Access Compliance Report

Public Rights-of-Way

(Curb Ramps)

Intersection ID: 47911	Main Street: ROOK_RD	Cross Street: RINGNECK_RD	Location: NW
ADA ID: 7EDE34AC8244	Ramp Type: PerpDiag	Initial Pass/Fail: Pass	Overall Compliance: No
		Severity Score: 0.25

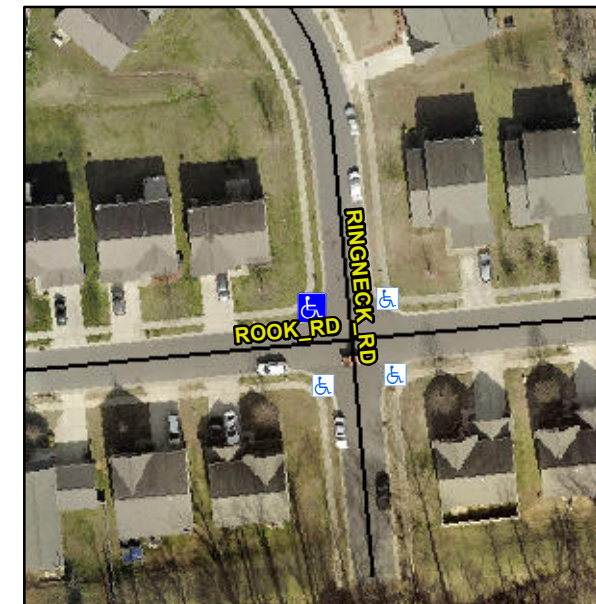
Not Found, R304.5.3, R304.2.1, R304.2.2-Perp, R304.3.2-Para, R305.2

Compliance	Description	Data	Compliance	Description	Data
N/A	Ramp Length (in)	48.5	Yes	Ramp Slope (%)	6.1
Yes	Ramp Width (in)	48.0	No	Ramp XSlope (%)	2.3
N/A	Flare Type LT	Sloped	N/A	Flare Type RT	N/A
N/A	Flare Slope LT (%)	5.2	Yes	Flare Slope RT (%)	3.4
N/A	Flare Traversable LT?	Yes	N/A	Flare Traversable RT?	Yes
No	Landing Length (in)	46.5	Yes	DWS Provided?	Yes
Yes	Landing Width (in)	48.0	Yes	DWS Contrast?	Yes
No	Landing Slope (%)	3.2	Yes	DWS Length (in)	24.0
Yes	Landing X Slope (%)	1.2	Yes	DWS Full Width?	Yes
N/A	Landing Curb? (Y/N)	No	No	DWS Offset (in)	4.5
N/A	Shared Landing?	No			
Yes	Gutter Ponding?	No	Yes	Gutter Slope (%)	1.9
Yes	Gutter Lip Ht (in)	0.0	Yes	Gutter X Slope (%)	1.9
N/A	Painted X Walk1?	No	N/A	Painted X Walk2?	No
	X Walk 1 Direction	To S		X Walk 2 Direction	To W
N/A	X Walk 1 Width (in)	N/A	N/A	X Walk 2 Width (in)	N/A
	X Walk 1 Slope (%)	9.2		X Walk 2 Slope (%)	3.6
	X Walk 1 X Slope (%)	1.6		X Walk 2 X Slope (%)	5.0

Remove & Replace Curb Ramp With Two New Directional Ramps or Equivalent.
